Highland
RIDGE RV

Recall Campaign

NHTSA#: 17V-561

CHANGING THE FEDERAL CERTIFICATION LABEL AND TIRE LABEL

FRONT RIGHT OFF DOOR SIDE (ODS)

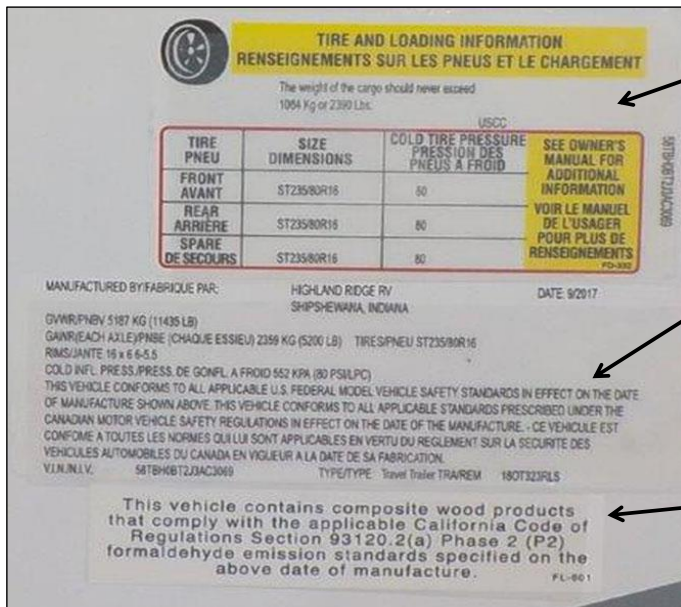
Replace Tire and Federal Labels due to incorrect tire size noted as 235/80R16 when correct size tires on unit are 235/85R16

Place the Tire Pressure label above the Federal Certification label (Do NOT cover the Federal Certification label)

Place the Federal Certification label under the Tire Pressure label

Do NOT cover up the Formaldehyde Label when placing the new labels
